PLANNING & ZONING COMMISSION REGULAR MEETING WEDNESDAY, JULY 10, 2024 - 3:30 PM MCALLEN CITY HALL, 1300 HOUSTON AVENUE CITY COMMISSION CHAMBERS, 3RD FLOOR

- a) SITE PLAN APPROVAL FOR LOT 1, SAVE-A-LOT SUBDIVISION, HIDALGO COUNTY, TEXAS; 2400 PECAN BOULEVARD. **(SPR2024-0005)**

SUBJECT: SITE PLAN APPROVAL FOR LOT 1, SAVE-A-LOT SUBDIVISION, HIDALGO COUNTY, TEXAS; 2400 PECAN BOULEVARD. (SPR2024-0005)

BLUEWAVE EXPRESS MCALEN 23 OVERALL SITE PLAN

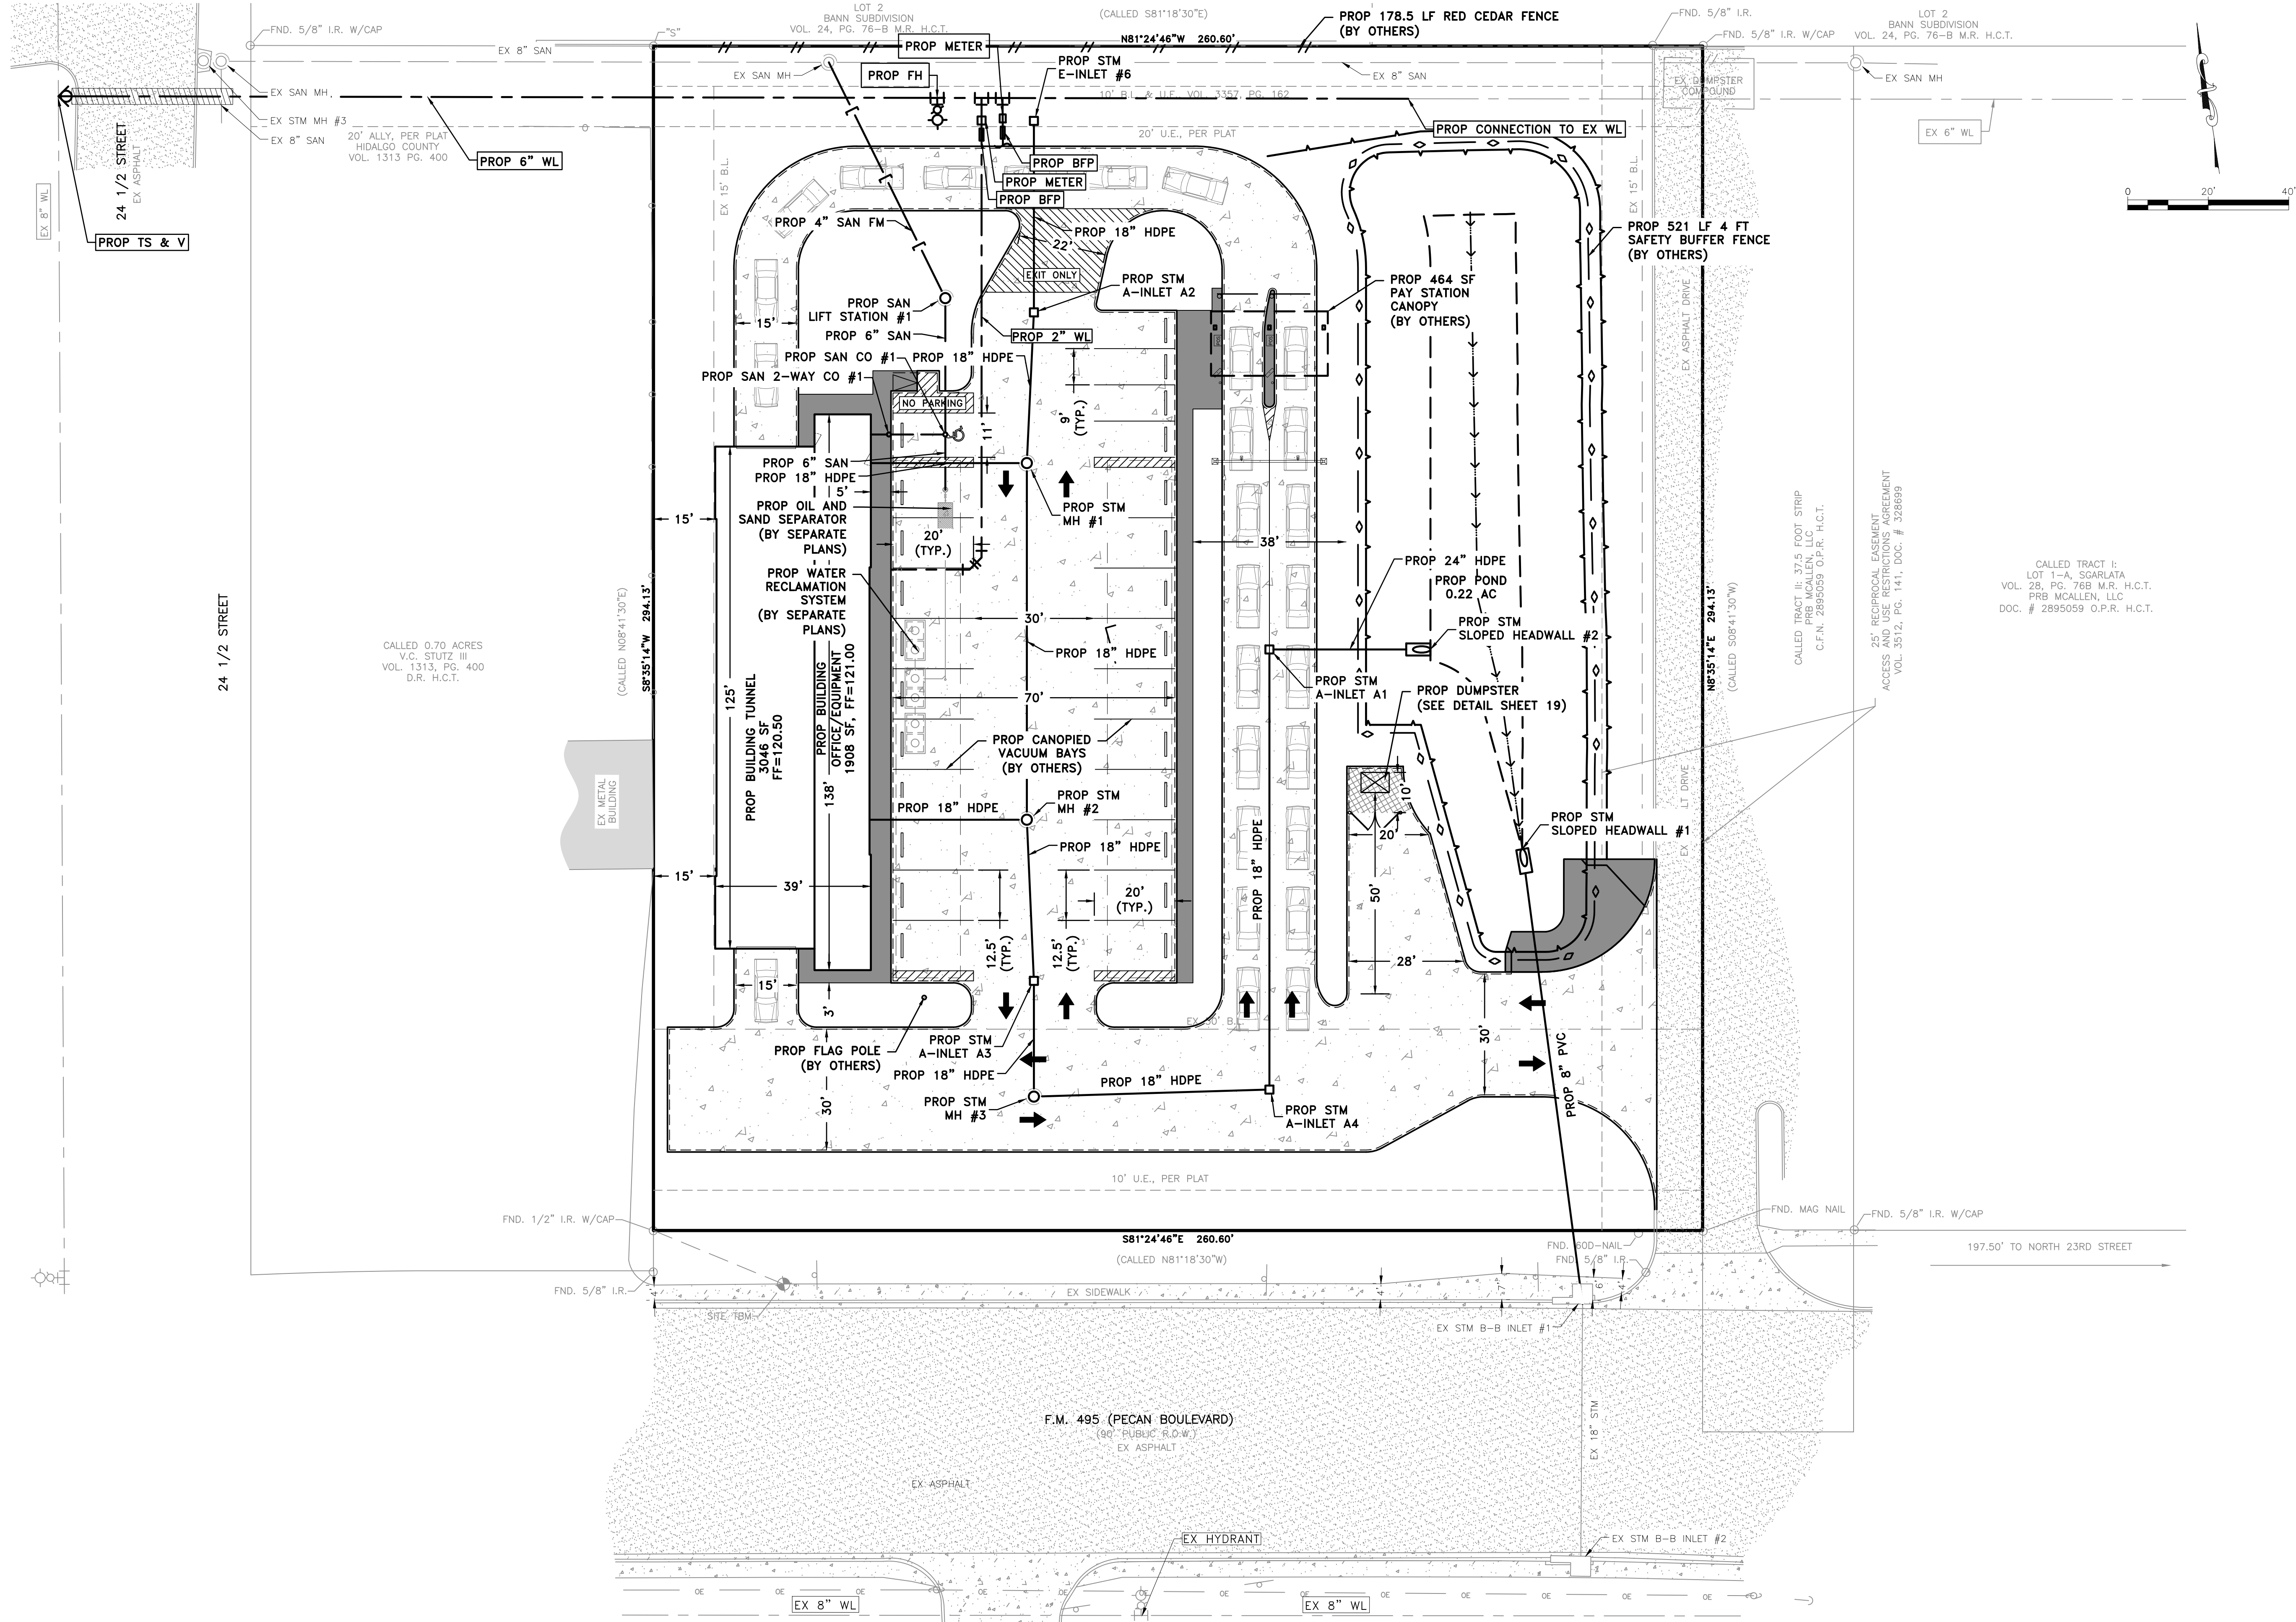
There is a 50-foot front yard setback and 10 foot utility easement along Pecan Boulevard, a 20-foot rear yard setback with a 20-foot utility easement and other setbacks as per Zoning Ordinance or greater for approved site plan or easements. No structures are permitted to be built over any easements. The new development will be complying with all required setbacks for the property.

A 4-foot-wide minimum sidewalk is required along Pecan Boulevard.

The Building Permit Site Plan must comply with requirements noted on the Development Team Review sheet. Must comply with any additional comments provided by all departments during the building permit stage.

RECOMMENDATION: Staff recommends approval of the site plan subject to the conditions noted, Building Permit requirements and the subdivision and zoning ordinances.
